ADDENDUM TO OWNER'S MANUAL

TIARA I-B

LP CONVERSION INSTRUCTIONS BURNER REMOVAL

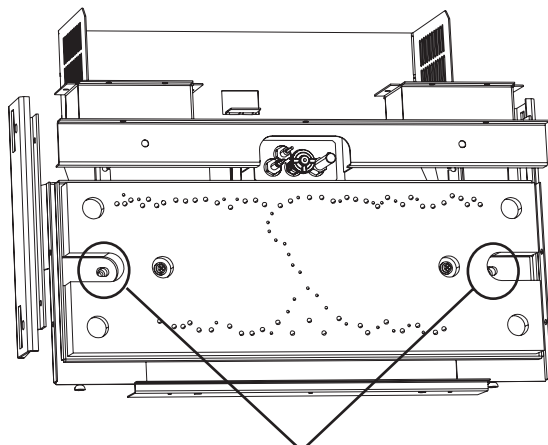
Page 24 of the Tiara I Owner's Manual, drawing (Figure 6.1) is showing to remove the burner screws. This separates the burner from the burner pan. This is incorrect.

INCORRECT

Remove the outer screws and then remove the burner and burner pan as one unit.

CORRECT

Remove 2 screws and remove burner and burner pan as one unit.
